Safety Evaluation Report Supporting the  
Renewal of the Facility Operating License for the  
Washington State University Modified TRIGA Nuclear Reactor  
License No. R-76  
Docket No. 50-027

September 2011  
Office of Nuclear Reactor Regulation  
U.S. Nuclear Regulatory Commission

Figure 6.1 Facility organization

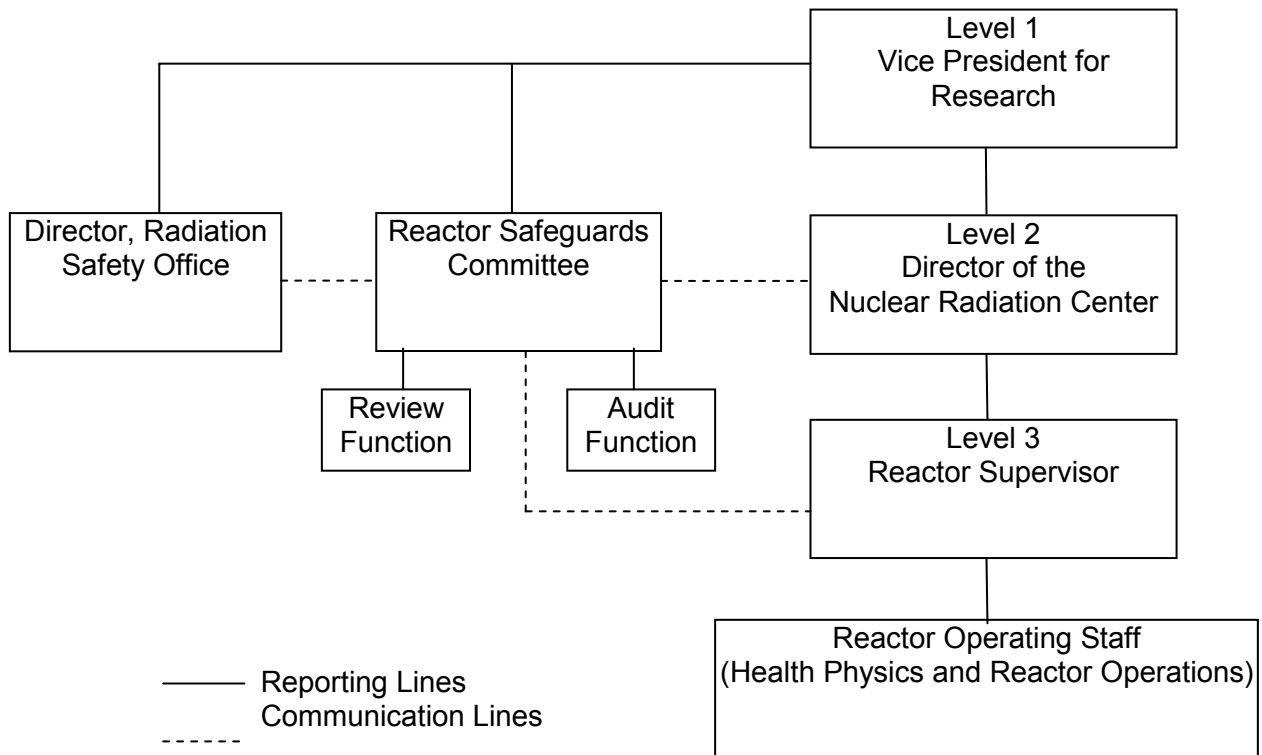
The licensee has modified TS 6.1 to include both the responsibilities and organization of individuals associated with the facility. TS 6.1 has been modified to clearly show the organizational arrangement for the radiation protection function. The licensee also modified Figure 6.1 to correct typographical errors and to identify the reporting and communication relations between the organizational units. TS 6.1 describes the organization and responsibilities of individuals in direct control of the facility and is consistent with the guidance provided in NUREG-1537 and ANSI/ANS-15.1-2007 and is therefore, acceptable to the NRC staff.
